**TOWN OF ACTON
DESIGN REVIEW BOARD**

Review Memorandum: Asa Parlin House Addition - 17 Woodbury Lane
February 29, 2024

Document Reviewed: A concept drawing entitled Asa Parlin House Rehabilitation, dated 2/13/2024, prepared by Bergman Hendrie + Archetype, architect for the project.

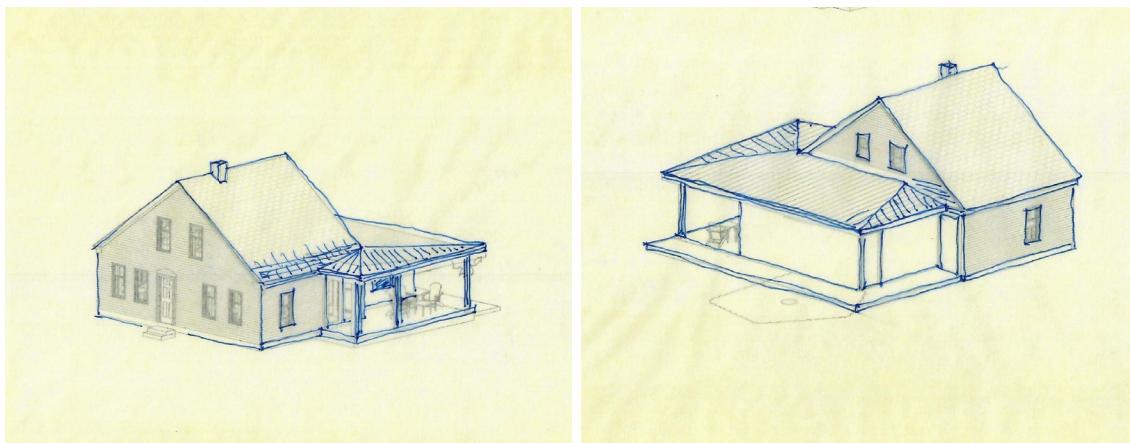
- DRB members are comfortable with the updated programming decisions made and with the general design direction of the addition.
- The low slung shed roof structure as proposed is an appropriate choice for the overall massing of the addition as it is deferential to the existing house. DRB members are in agreement with the intent for the addition to be clearly differentiated from the original house architecture. However, DRB members are not comfortable with the awkward relationship that develops as the shed roof intersects with the the original house and its gable roof. The DRB propose that the shed roof be reshaped to a modified hip that will align the addition's roof edge with the existing gable roof as shown in the following sketch images.

- The suggestion of a standing seam metal roofing system is a good choice. It is recommended that a waterproof membrane be installed below the metal roof. DRB members prefer that the addition exterior materials be distinct from the existing house finishes.

- The DRB recommends that the choice for exterior siding of the addition be smooth vertical tongue and groove boards to distinctly contrast with the traditional horizontal siding of the house.

- The DRB would prefer the window from the kitchen space be shifted to the south facing side of the porch, where it will be less of an obvious visual, yet offer an opportunity for serving of ice cream and other treats during events that likely will be take advantage of the available green space.

- The suggestion of simple 4x4 posts to support the roof at the porch appears appropriate.
- The DRB requests the project proposal return for a further review by the board after the addition is more fully developed and with the landscape concept for the adjacent southern green area
